**AMENDMENTS TO THE DRAWINGS**

### **REMARKS**

Application No. 10/019,646  
Amendment dated February 1, 2006  
After Final Office Action of November 1, 2005

Docket No.: 2611-0167P

FIG.11

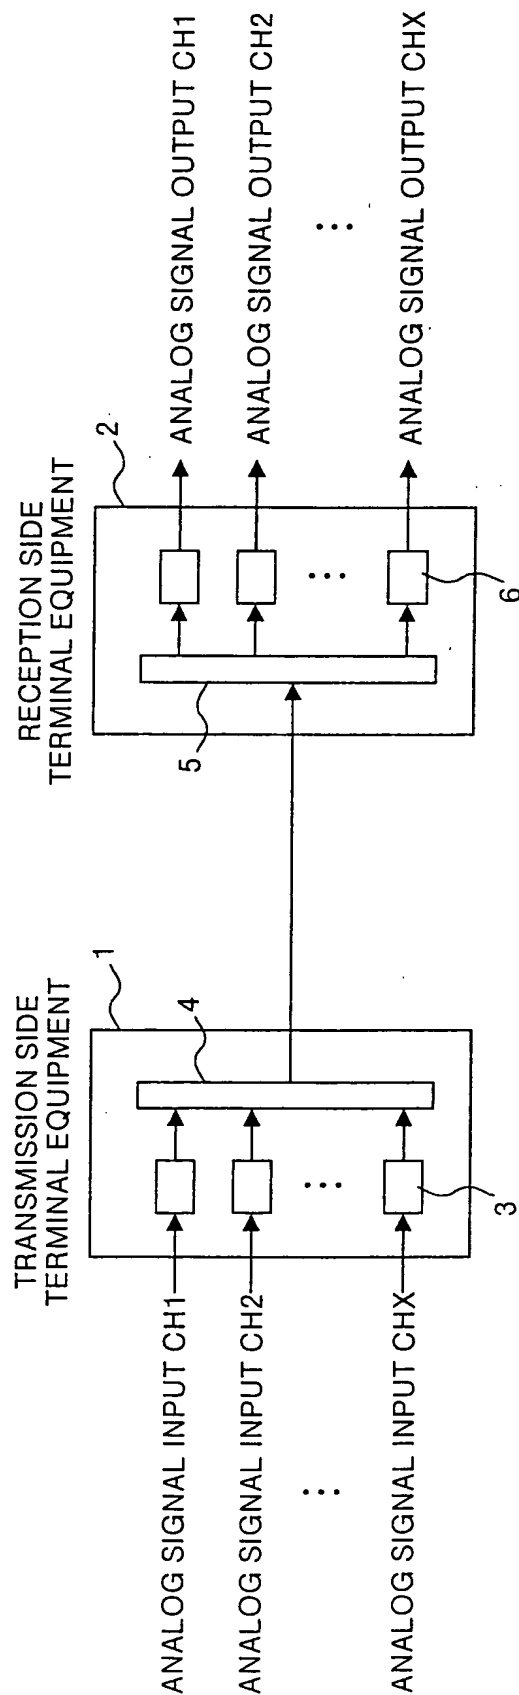
The Examiner objected to Figure 11 because it should be designated by a legend indicating that the figure illustrates that which is old. Attached hereto are drawing corrections in which the legend --Conventional Art-- has been included in Figure 11. Thus, withdrawal of this rejection is respectfully requested.

The attached sheet of drawings includes changes to Fig. 11. In Fig. 11, has been amended so that it now includes the label --Conventional Art--.

CONVENTIONAL ART
